**ENVIRONMENTAL BOARD MOTION FORM**

**NAME & NUMBER OF PROJECT:** Harris Branch PUD (Scots Glen) Amendment #13  
C814-90-0003.13

**REQUEST:** Requests to amend the PUD ordinance #901213-H that  
include exceptions to certain watershed requirements.

**SUBJECT:** Harris Branch PUD Amendment #13

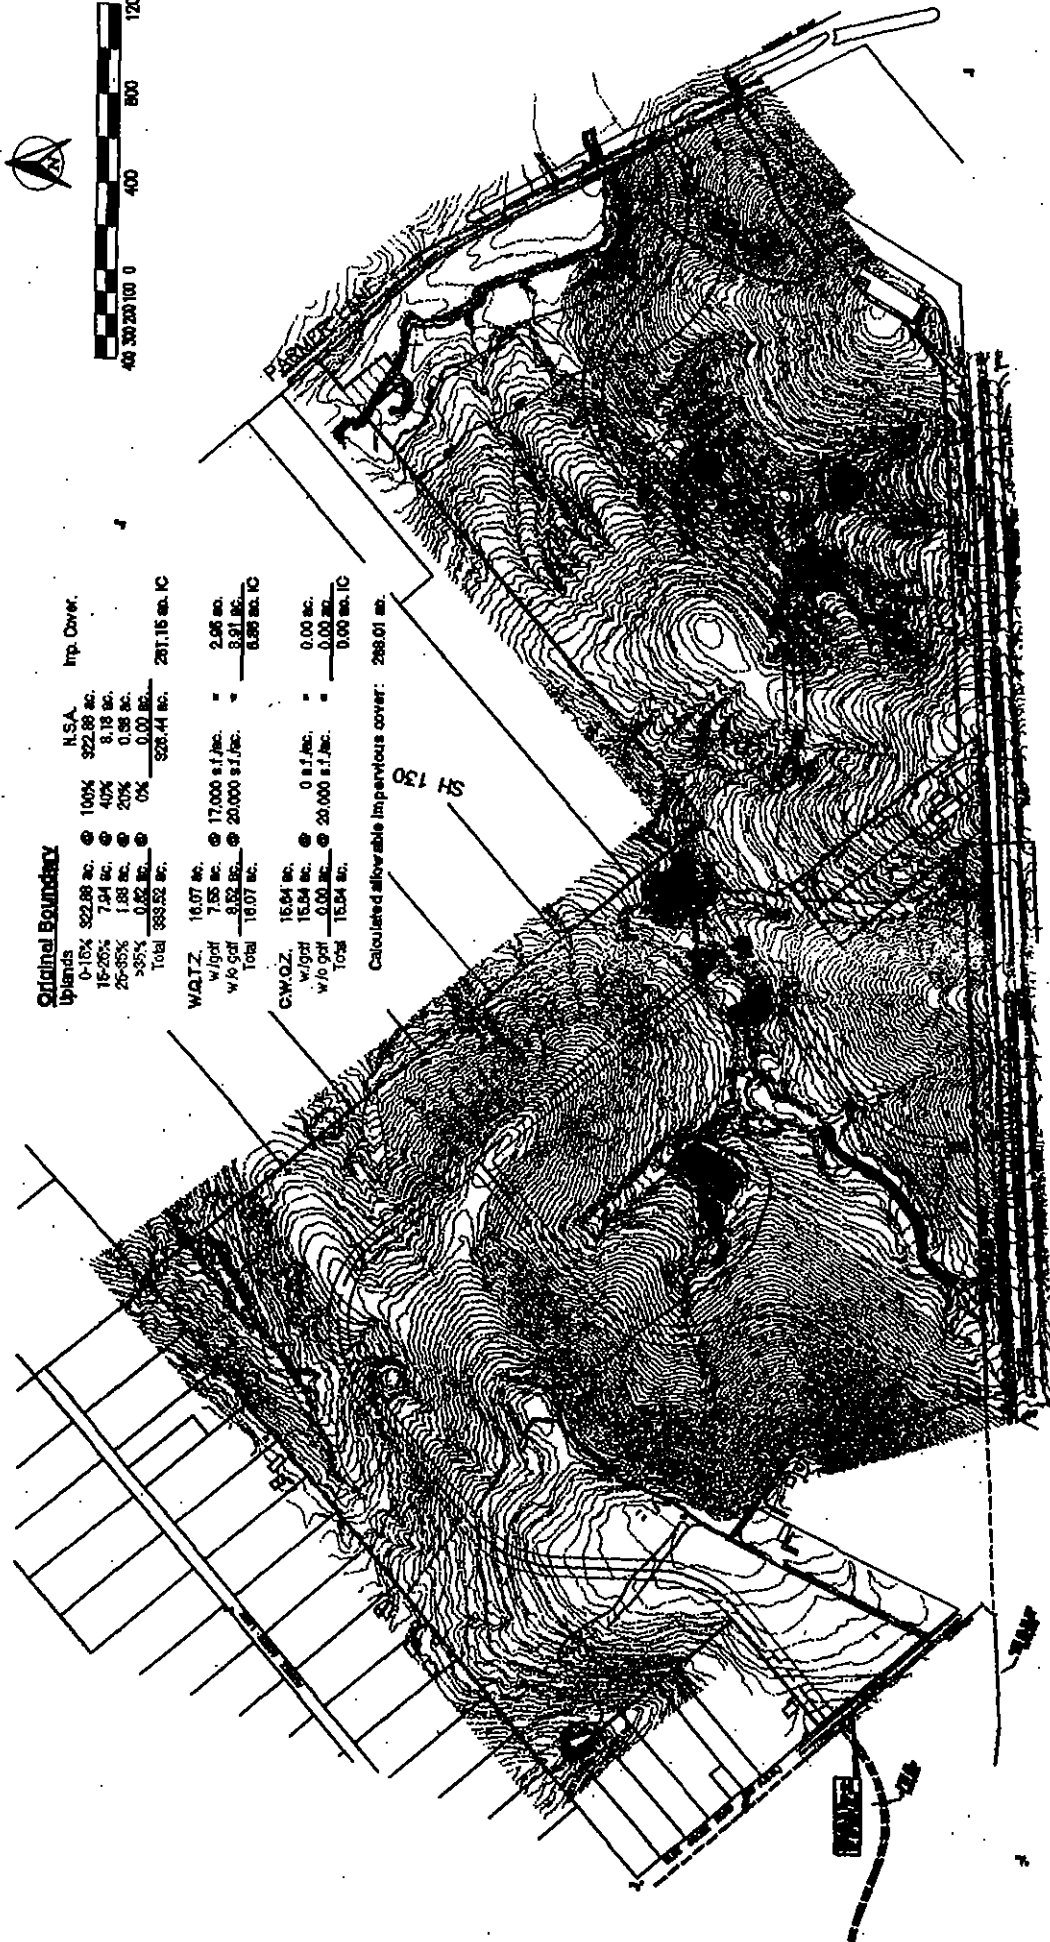
9. Water features found within the area of the PUD will be addressed in the manner previously agreed to with the Staff regarding the preliminary plan, a copy of which is attached as **Exhibit "A"**.

10a Staff and applicant agree to address development regarding the Critical Water Quality Zone and Water Quality Transition Zone as shown on the attached Equinox Centre Environmental Base Map and staff supports applicants request for a variance eliminating the WQTZ on Lots 4, 5 and 6 and not developing impervious cover in the WQTZ for Lot 3 but allowing storm water facilities therein.

Environmental Staff is recommending this variance.
